## AFCEE Galena Triad Meeting No. 4

ATTENDEES: See Attached  
FROM: CH2M HILL  
DATE: August 2, 2011

**Site Name: UST1770**  
**Investigation Type: SC**  
**Analytes: Petroleum Hydrocarbons**  
**Media: Groundwater**  
**SLs: Groundwater Project SLs**  
**Data Range: 2010 and 2011**

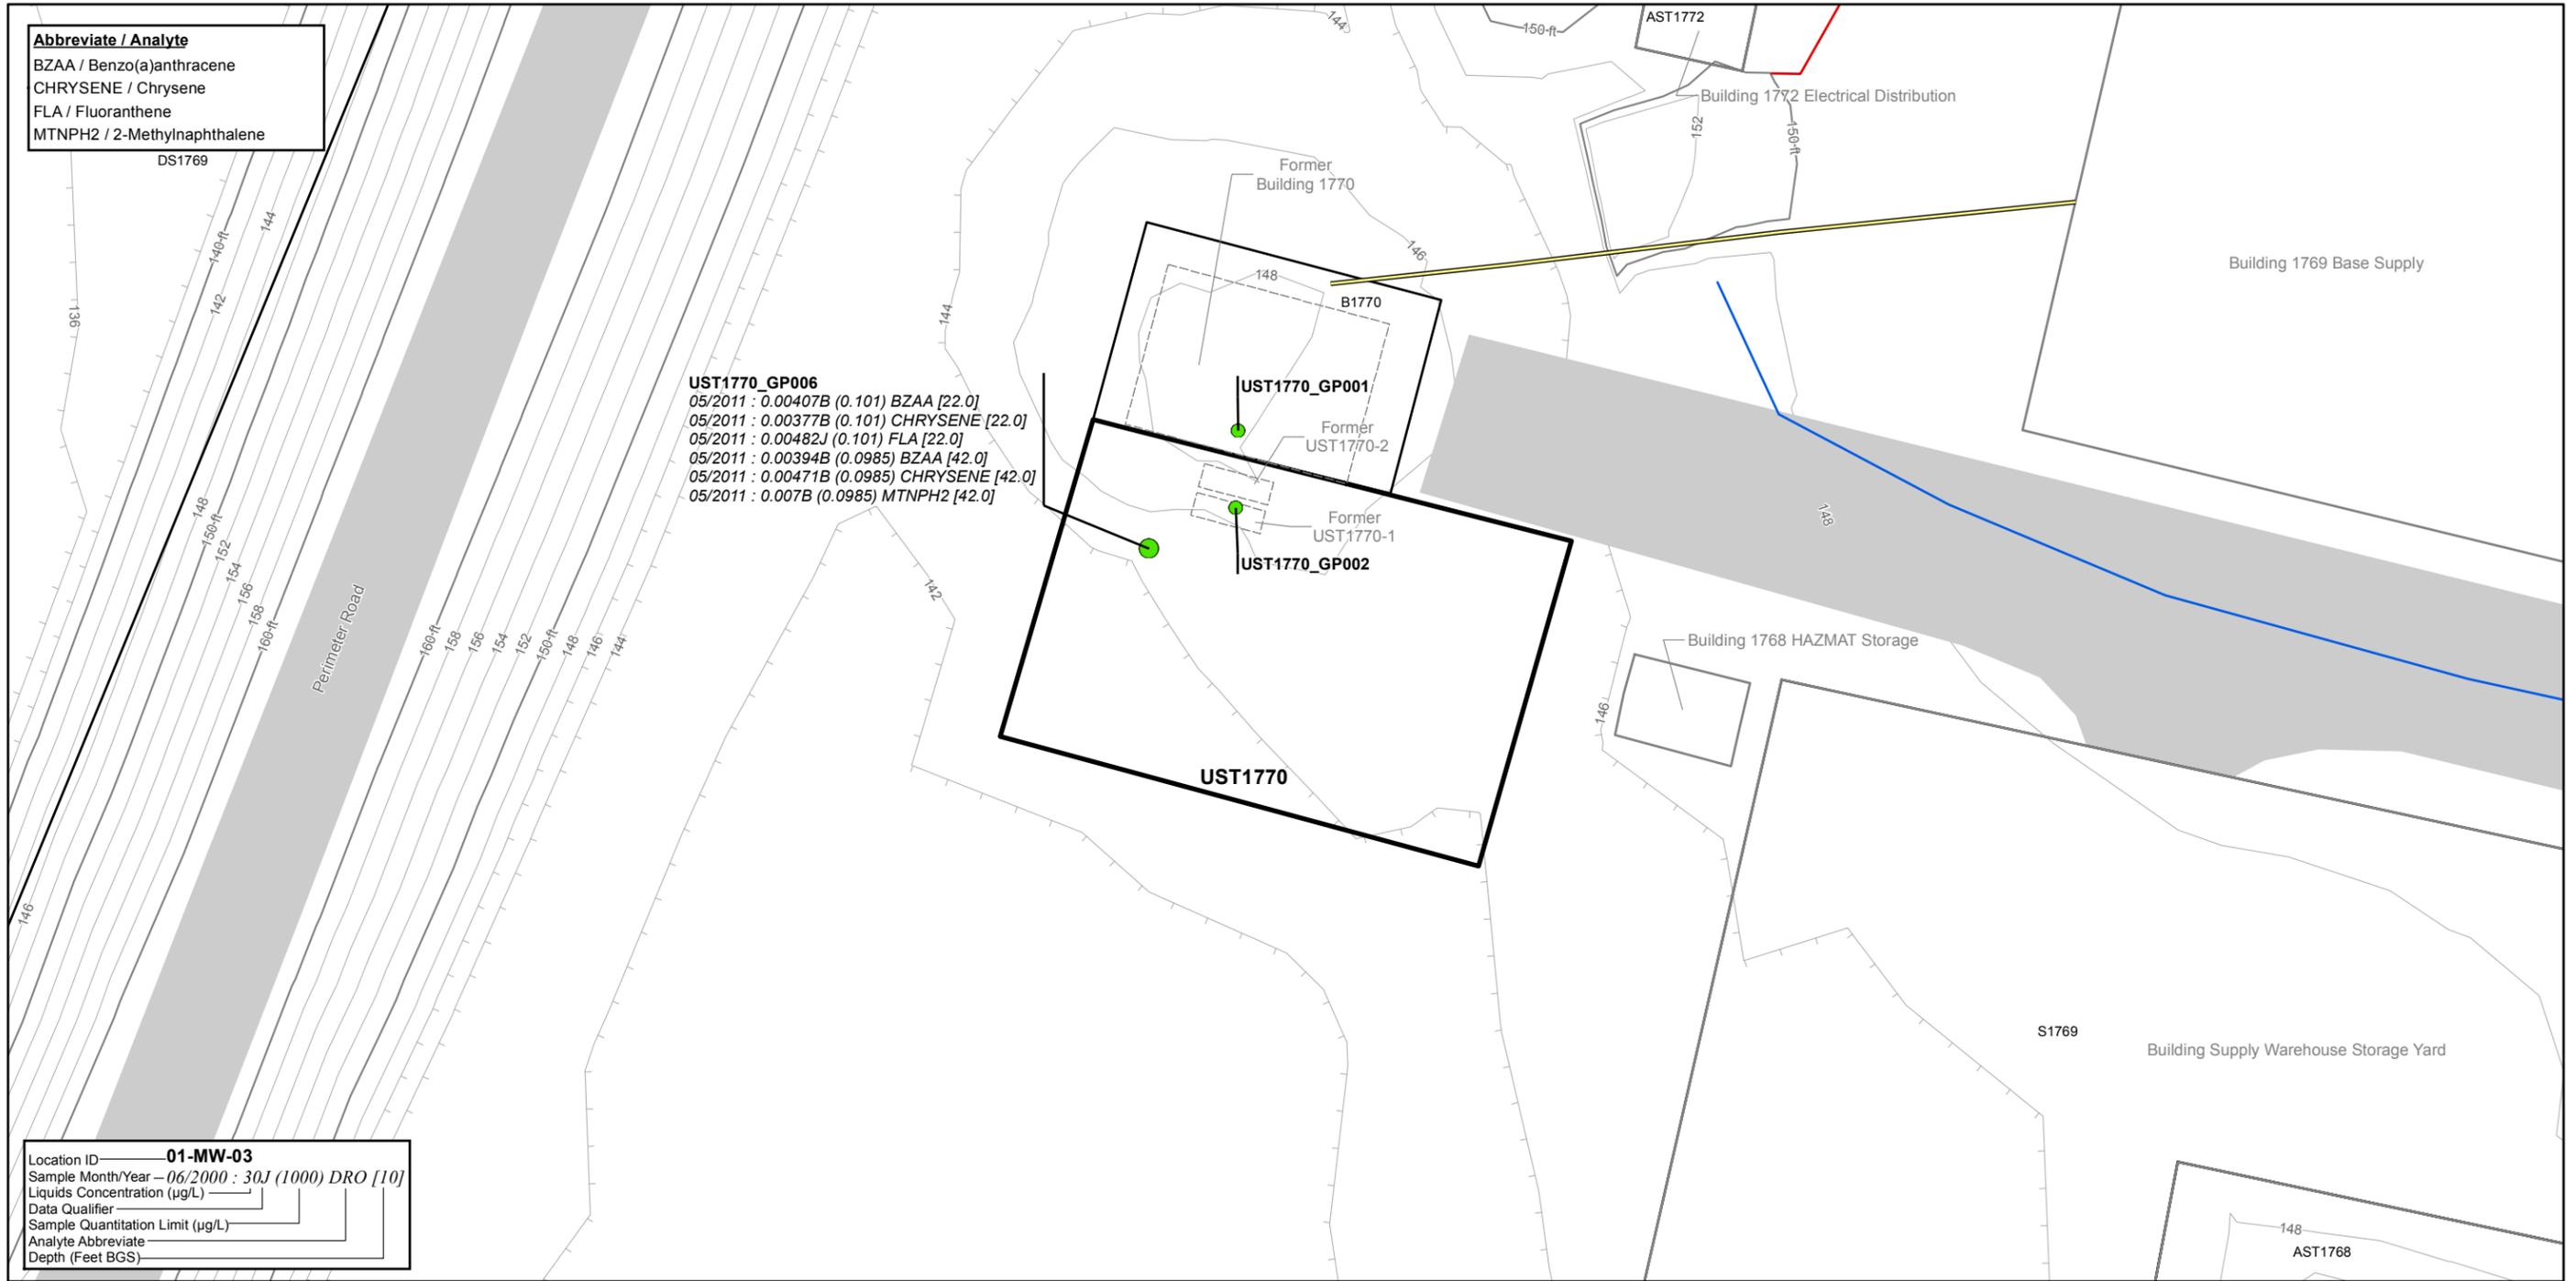
Kate presented a figure on UST1770 SVOC sampling results; in 2010, had exceedances down to 10 feet. Had three stepouts down to 41 feet, and there were no exceedances.

Amanda asked Kate whether GP006 and GP007 were supposed to be groundwater grab samples also. We do have groundwater data but it was not available to present today.

- A Triad decision that no additional soil stepout sampling will be required at this site was proposed. Because Fred is no longer on the call, will ask for his concurrence when the minutes are sent to him (and the groundwater figure will be sent with the minutes also).

Note: follow-up on the groundwater sampling results for GP006 and GP007 indicated that there were no detectable analytes above screening levels. Figures with detected concentrations of hydrocarbons, VOCs, and SVOCs are submitted with the meeting minutes.

**Step-Out Samples**  
**Site Name: S1850**  
**Investigation Type: RI**  
**Analytes: All Exceedences (excludes Metals)**  
**Media: Soil**  
**SLs: Soil Extent**  
**Data Range: Historical and 2010**

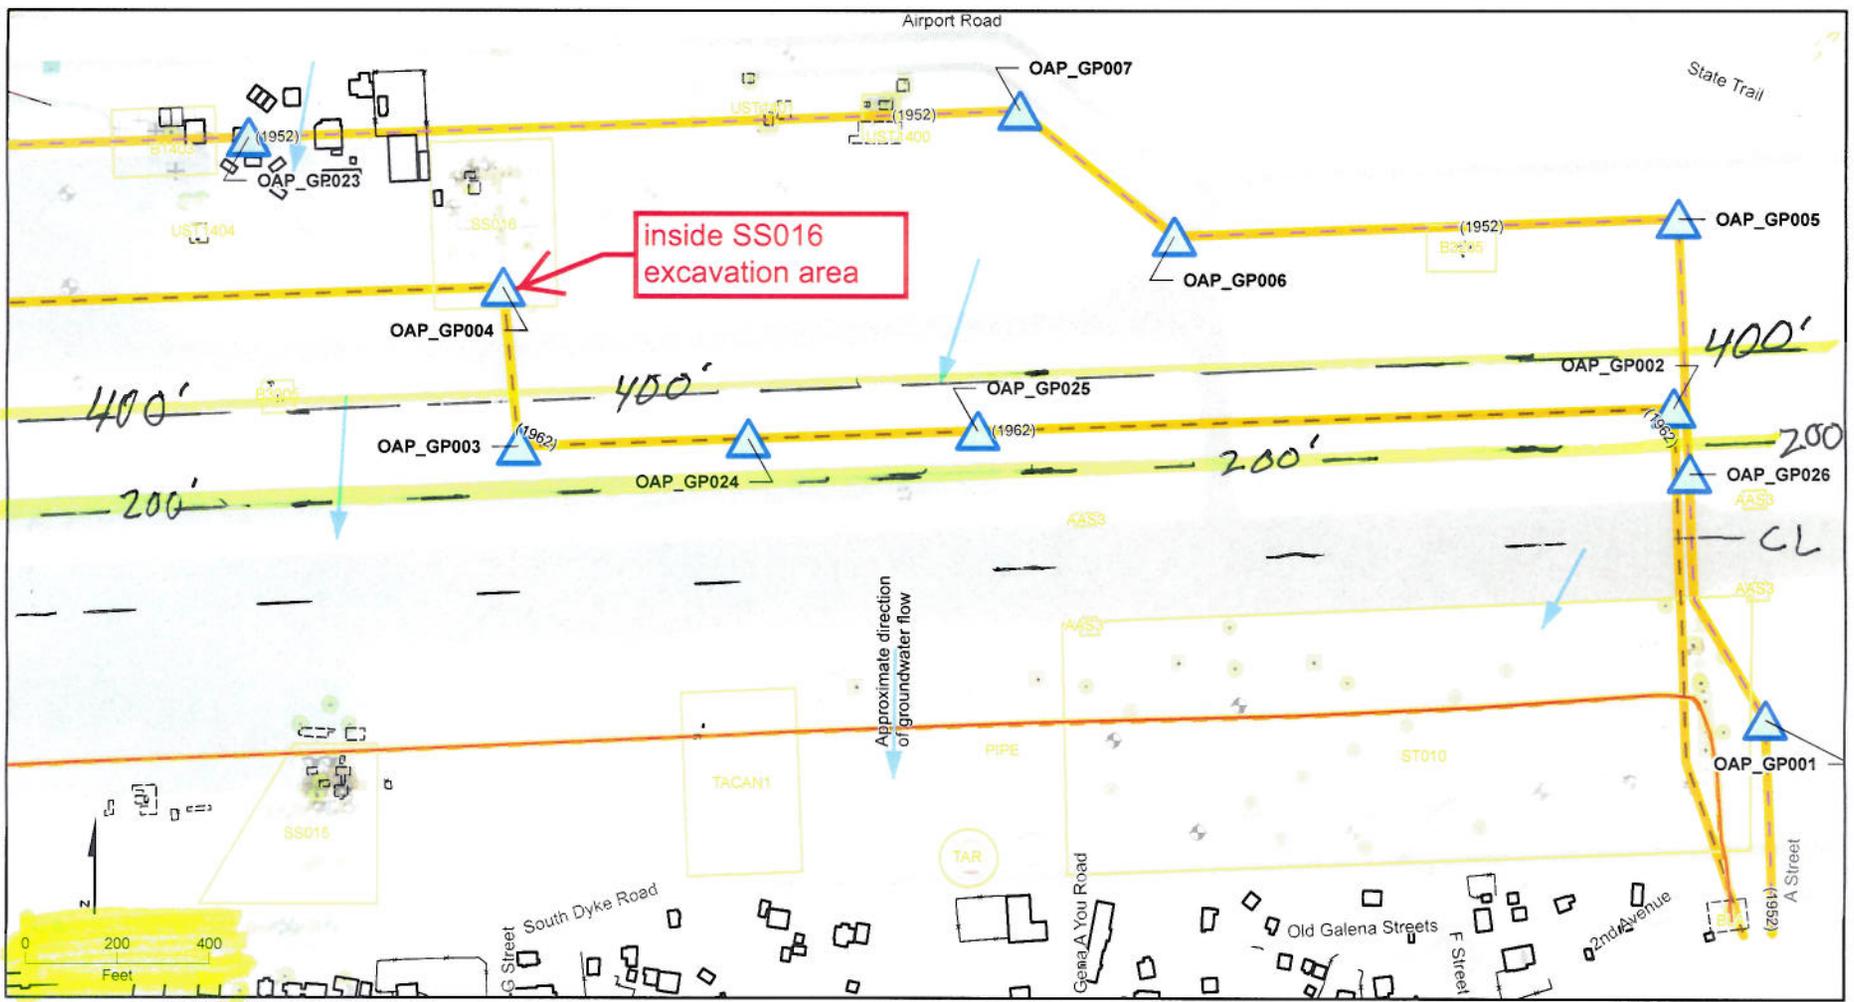
Kate next presented a figure showing offsite lab data for S1850.

- After discussion, two proposed stepouts (GP008 and 009) were moved to approximately 10 feet outside of the fenced area to the west and south, and a grab groundwater sample was added to GP008 (as long as the water table is higher than 35 feet below ground surface, which is the top of the screen interval of the existing monitoring well south of the storage yard). If groundwater is deeper than 35 feet, will not collect the grab groundwater sample. Analytes for soil and groundwater are VOCs only.
